Keithley Instruments
28775 Aurora Road
Cleveland, Ohio 44139
1-800-833-9200
tek.com/keithley

- Model 2461 High-Current SourceMeter® Instrument
- 2461-NFP
- 2461-RACK
- 2461-NFP-RACK

VERSION 1.7.7 RELEASE

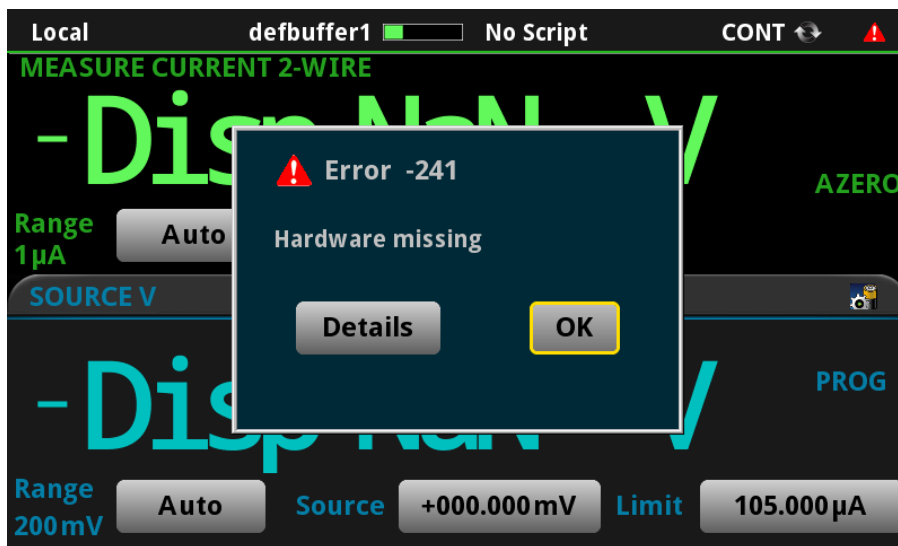
PR61502 From a cold power up, the Model 2461 SMU will sometimes fail with the following error message and will not operate properly.

If this issue occurs, a subsequent power cycle will allow the instrument to power up properly.

This issue has been corrected with firmware revision v.1.6.5.
